SIB 52 07 25

M5 HEAD RESTRAINT GROANING NOISE

2026-06-03

This Service Information Bulletin (Revision 3) replaces SI B52 07 25 **dated January 2026**.

CAUSE

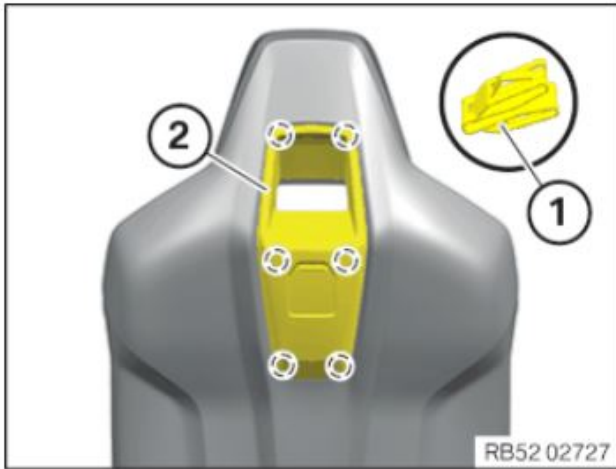
The decorative trims on the head restraints of the driver's seat and front passenger seat cause groaning noises on any route, at any temperature, even in a slightly reclined position.

The edge of the aperture trim rubs against the seat leather upholstery at the point of contact.

Replace the aperture trim on both seats in case of a noise concern with revised part number 52 10 7885235.

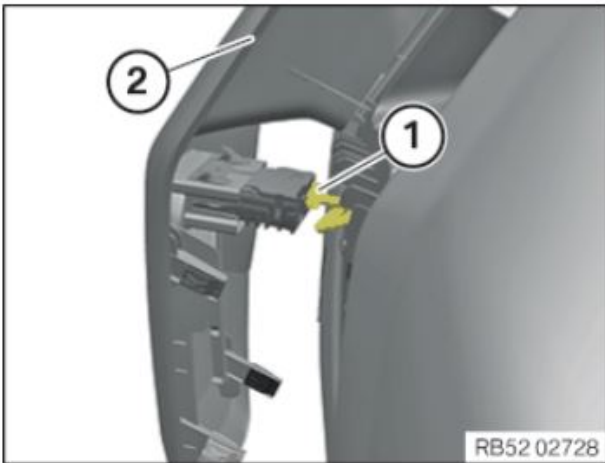
If the decorative trim causes groaning noises, **replace the decorative seat aperture trim (1) with an improved part.**

To remove the front decorative seat aperture trim, you must first remove the trim (2) from the rear of the seat. There are 6 retainer clips (1).

The revised front aperture trim can be identified by a green dot sticker.

The improved part with the green dot sticker has strips of felt attached.
Do not install the part if the felt is missing.
